SYNGENE INTERNATIONAL LTD, VELANKANI TECH PARK, ACCESSIBILITY AUDIT REPORT

PREPARED BY SVADHIN SOLUTIONS

GROUND FLOOR, SYNGENE INTERNATIONAL, VTPL – ACCESSIBILITY OVERVIEW

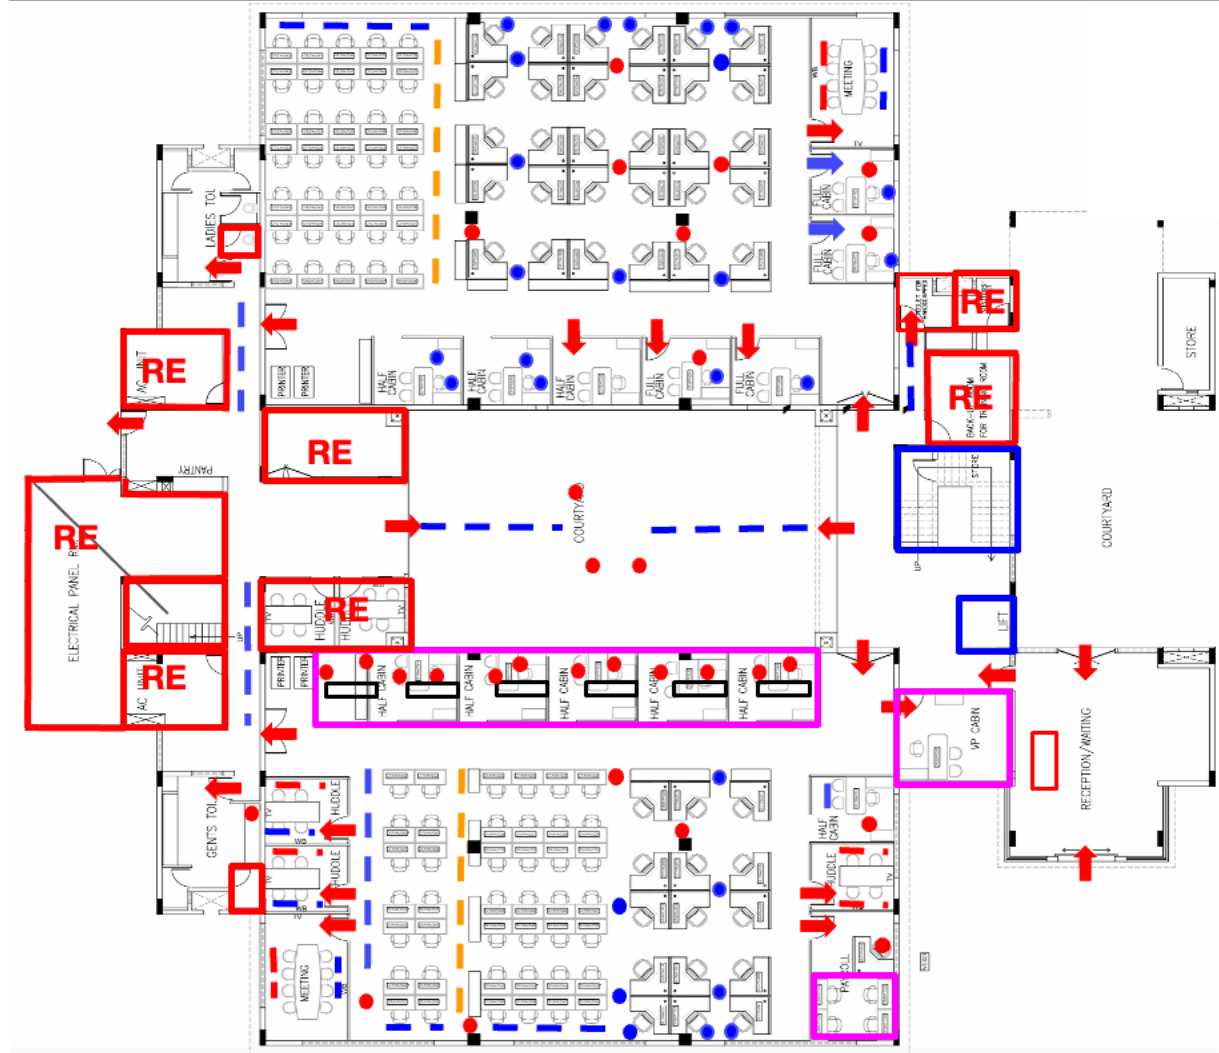
AREAS				
BUILDING MAIN ENTRANCES	□/X	X	✓	✓
RECEPTION	X	X	□	□
PERSONAL CABINS	X	X	✓	✓
CONFERENCE ROOMS	X	X	✓	□
MEETING ROOMS	X	X	✓	✓
COURTYARD	X	X	✓	✓
PANTRY	X	X	✓	✓
PWD RESTROOM	X	X	✓	□
MEN'S & WOMEN'S RESTROOMS	-/X	X	✓	□
MAIN LIFT & LIFT LOBBY	□	X	✓	✓
STAIRCASES	□/X	X	✓	✓
EMERGENCY EVACUATION ROUTES & EXITS	□	X	□	□

FIRST FLOOR, SYNGENE INTERNATIONAL, VTPL – ACCESSIBILITY OVERVIEW

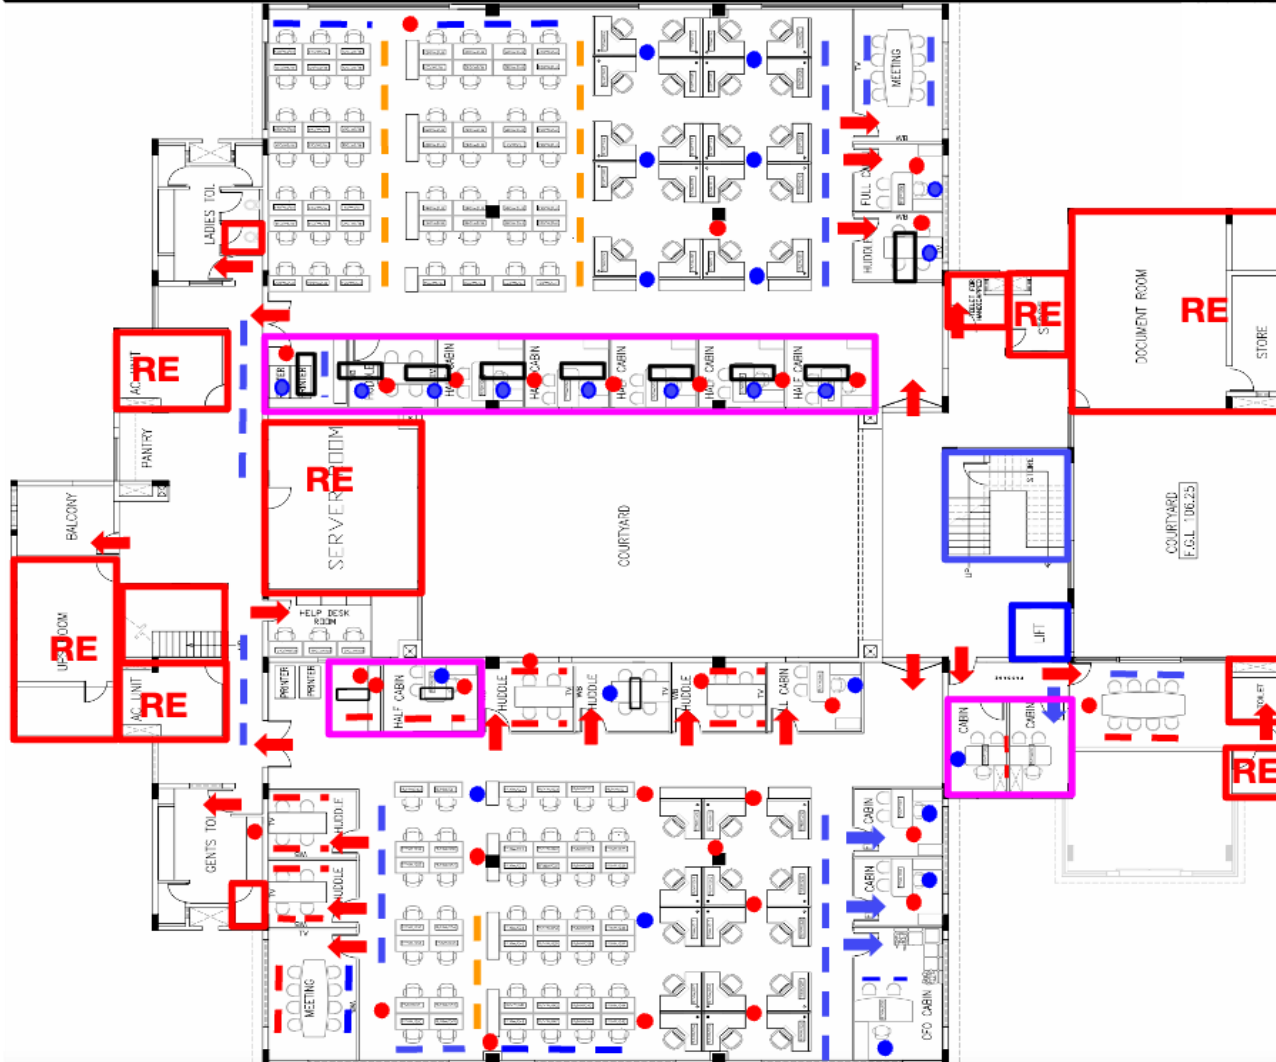
AREAS				
IT HELP DESK	X	X	✓	✓
PERSONAL CABINS	X	X	✓	✓
CONFERENCE ROOMS	X	X	✓	□
MEETING ROOMS	X	X	✓	✓
BALCONY	X	X	✓	✓
PANTRY	X	X	✓	✓
PWD RESTROOM	X	X	✓	□
MEN'S & WOMEN'S RESTROOMS	-/X	X	✓	□
MAIN LIFT & LIFT LOBBY	□	X	✓	✓
STAIRCASES	□/X	X	✓	✓
EMERGENCY EVACUATION ROUTES & EXIT STAIRCASES	□	X	□	□

SECOND FLOOR, SYNGENE INTERNATIONAL, VTPL – ACCESSIBILITY OVERVIEW

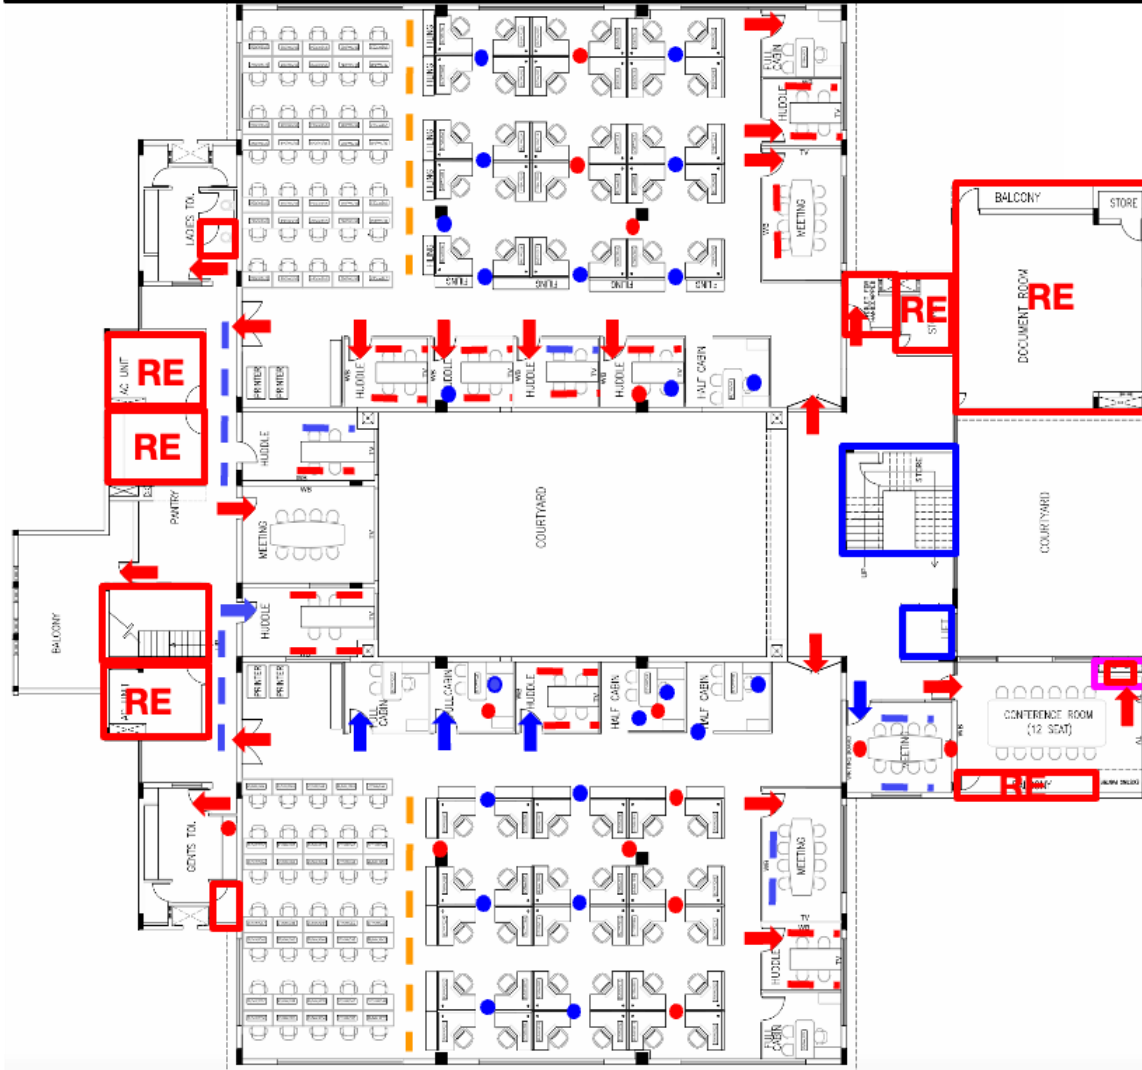
AREAS				
PERSONAL CABINS	X	X	✓	✓
CONFERENCE ROOMS	X	X	✓	□
MEETING ROOMS	X	X	✓	✓
BALCONY	X	X	✓	✓
PANTRY	X	X	✓	✓
PWD RESTROOM	X	X	✓	□
MEN'S & WOMEN'S RESTROOMS	-/X	X	✓	□
MAIN LIFT & LIFT LOBBY	□	X	✓	✓
STAIRCASES	□/X	X	✓	✓
EMERGENCY EVACUATION ROUTES & EXIT STAIRCASES	□	X	□	□

THIRD FLOOR, SYNGENE INTERNATIONAL, VTPL – ACCESSIBILITY OVERVIEW

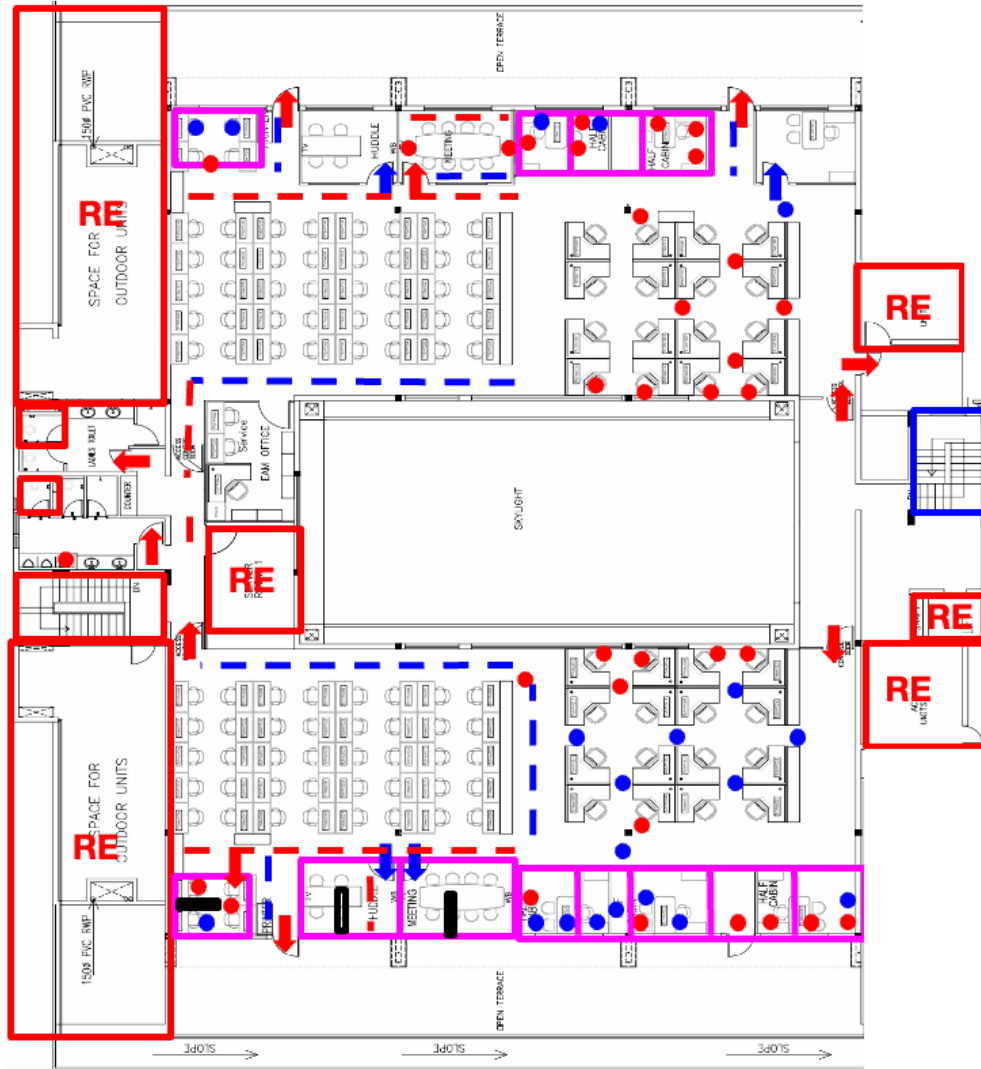
AREAS				
PERSONAL CABINS	X	X	✓	✓
CONFERENCE ROOMS	X	X	✓	□
MEETING ROOMS	X	X	✓	✓
BALCONIES	X	X	✓	✓
PANTRY	X	X	✓	✓
MEN'S & WOMEN'S RESTROOMS	-/X	X	✓	□
MAIN LIFT & LIFT LOBBY	□	X	✓	✓
STAIRCASES	□/X	X	✓	✓
EMERGENCY EVACUATION ROUTES & EXIT STAIRCASES	□	X	□	□

CAMPUS MAIN ENTRANCES & EXITS

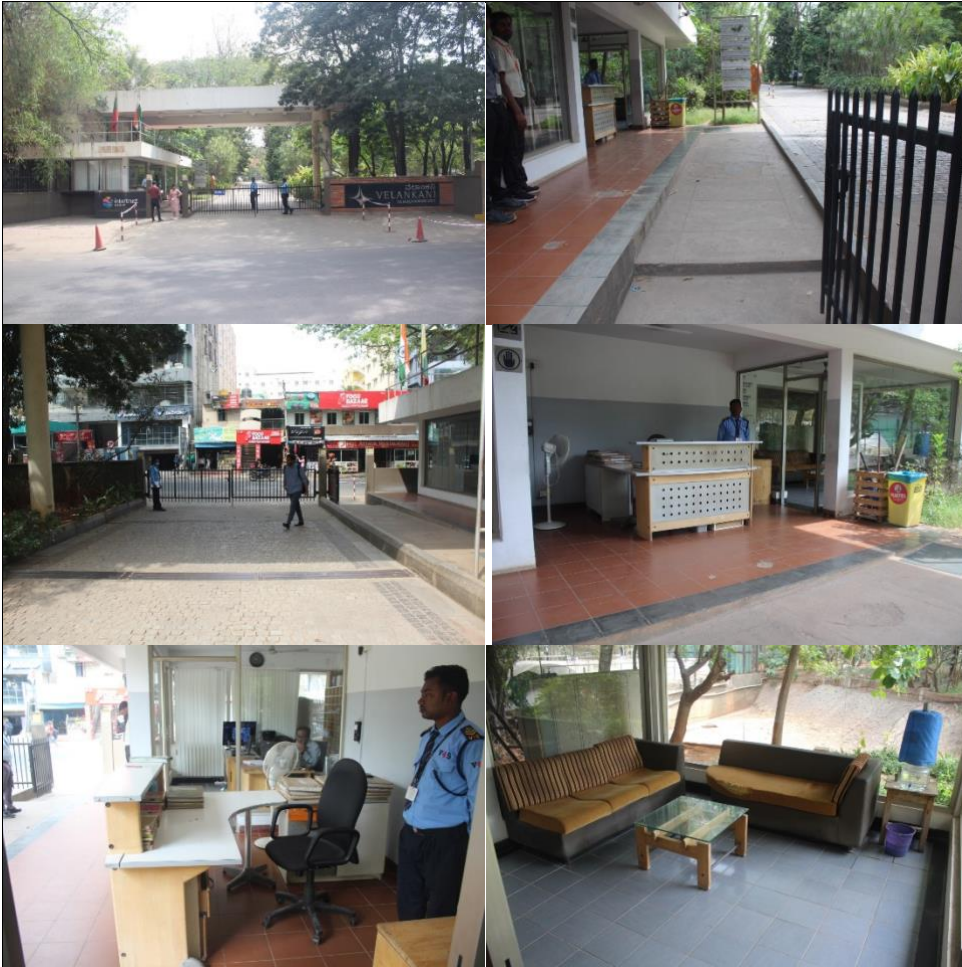
- There is no pedestrian pathway demarcated and kept at Gate 5 which would put PwD pedestrians walking into the campus at safety risk as they would be using the vehicular route

- The speed breaker in front of the Gate 5 in the pedestrian walkway makes this route harder to navigate for certain PwDs making this entry gate non-compliant

- The Gate 5 security sign in counter access is at step level and does not have provision for an accessible ramp, step height is non-compliant and hard to use by most PwDs and does not have any handrails for support making this entry inaccessible and non-compliant for PwDs

- The height of the security sign-in counter at Gate 5 is inaccessible for wheelchair users and certain other PwDs
- There is no dedicated walkway leading from Gate 5 to the building entrance making this route non-compliant and unsafe for PwD movement

- Gate 6 pedestrian exit path has no dedicated walkway and has uneven surface making it non-compliant and unsafe for certain PwDs
- The turning space after the Gate 6 pedestrian exit gate is non-compliant and will be hard for certain wheelchair users to use

- Gate 6 security booth is at a step level does not have a provision for an accessible ramp making entry to this security booth non-compliant and inaccessible for wheelchair users

- Gate 6 security booth is at a step level and the entry steps have no handrails, antiskid markings on the step treads and a clear landing space from the steps to the entry door making this inaccessible and non-compliant for certain PwDs

<ul style="list-style-type: none"> ➤ Gate 6 security booth entry door has inaccessible push and pull side door clearances, handles placed at inaccessible heights with no colour contrast against the door frame, and there is no provision for an accessible signage making this entry non-compliant for PwDs
		<ul style="list-style-type: none"> ➤ Gate 2 pedestrian entry has a step level access without provisions for an accessible ramp making this entry non-compliant and inaccessible for wheelchair users and certain other PwDs
		<ul style="list-style-type: none"> ➤ The path leading to the security sign in counter at Gate 2 has a level deference making it unsafe for certain PwDs
		<ul style="list-style-type: none"> ➤ The security reception/sign in counter at Gate 2 are at an inaccessible height, it does not have dual level counters with a lower counter having knee clearance and lacks accessible identification signage making this counter non-compliant and inaccessible for PwDs

<ul style="list-style-type: none"> ➤ The visitors waiting lounge at Gate 2 has non-compliant door width, handles placed at inaccessible height and does not have contrast against the door frame, door doesn't contrast against the background, no push side door clearance and no provision for an accessible signage making this entry inaccessible and non-compliant for PwDs
		<ul style="list-style-type: none"> ➤ The water dispenser placement in Gate 2's visitors waiting lounge makes it non-compliant and inaccessible for certain PwDs
		<ul style="list-style-type: none"> ➤ The light switches in the Gate 2 visitors waiting lounge are placed at a non-compliant height and do not contrast against the back ground making them non-compliant for certain PwDs
		<ul style="list-style-type: none"> ➤ Most of the identification and directional signages at the gates and along the campus pathway are placed at non-compliant and inaccessible heights and none of them have provisions for braille and tactile making them non-compliant and inaccessible for PwDs

<ul style="list-style-type: none"> ➤ All the three campus entry/exit gates lack clear directional signage leading to the Syngene building making navigation non-compliant and inaccessible to PwDs

- There is no continuously running footpath leading from Gate 2 to the building entrance and the walkways have uneven surface making this route non-compliant and unsafe for PwD movement
- There are no tactile pictographic maps placed at the different gates as required by compliance to support people with visual impairment to navigate around the campus to reach their destinations
- There are no assistance protocols in place to support PwDs including how to interact with people with different disabilities as well as training in sign language to support people with hearing impairment
- Gratings around the campus pedestrian routes have non-compliant opening widths and can be safe for PwDs using mobility aids

LIFT & LIFT LOBBY (MAIN)

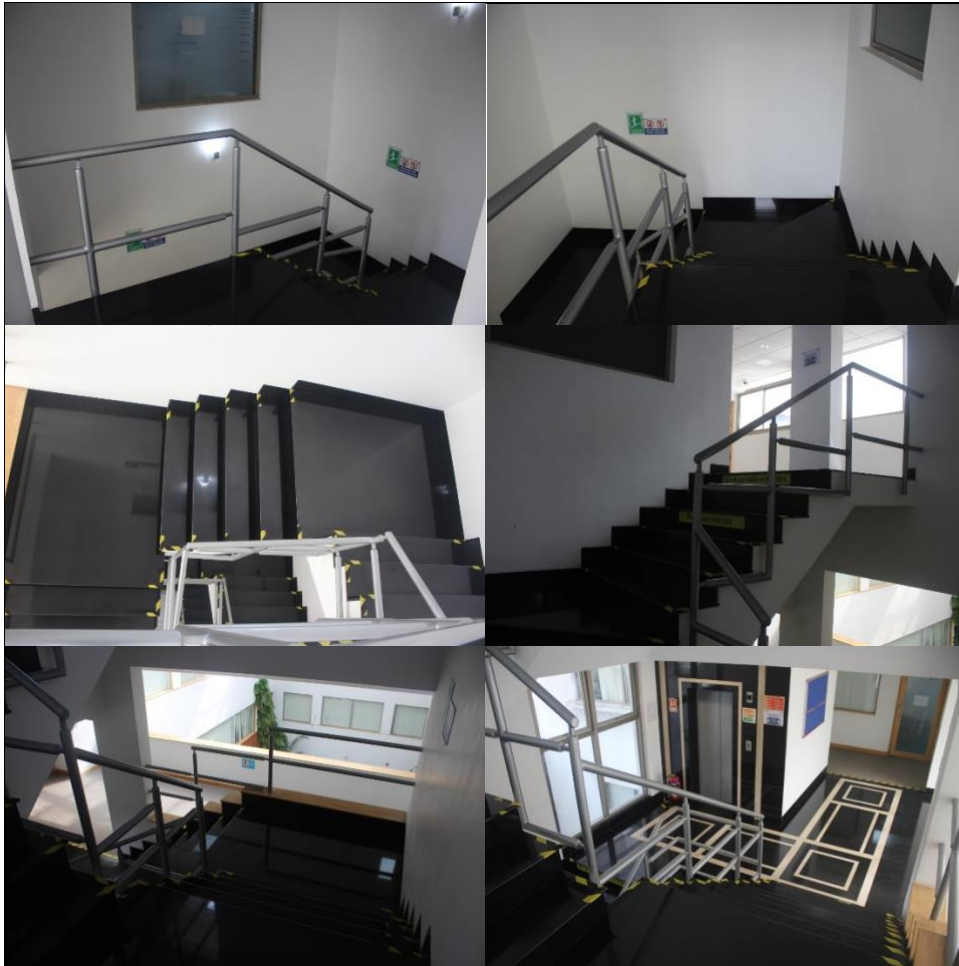
- There are no floor identification signage in all the three lift lobbies with provisions for braille and tactile making identification and navigation non-compliant and inaccessible for PwDs

- The emergency and safety instructions in all the three lift lobbies as well as inside the lift are placed at non-compliant and inaccessible heights with no provisions for braille and tactile making them non-compliant and inaccessible for PwDs

- The lift car has inaccessible door width and non-compliant internal dimensions making this lift car non-compliant and inaccessible for PwDs
- The lift call buttons are placed at inaccessible heights without provisions for braille making them non-compliant and inaccessible for PwDs

- There are no compliant type of handrails on all three sides inside the lift making the lift non-compliant and inaccessible for PwDs
- The control panel and emergency call button inside the lift are placed at inaccessible heights without provisions for braille making them non-compliant and inaccessible for PwDs

- The emergency phone inside the lift is placed at an inaccessible height and does not have an accessible identification signage making it non-compliant and inaccessible for PwDs
- The lift has no audio out to assist people with visual impairment making it inaccessible for them
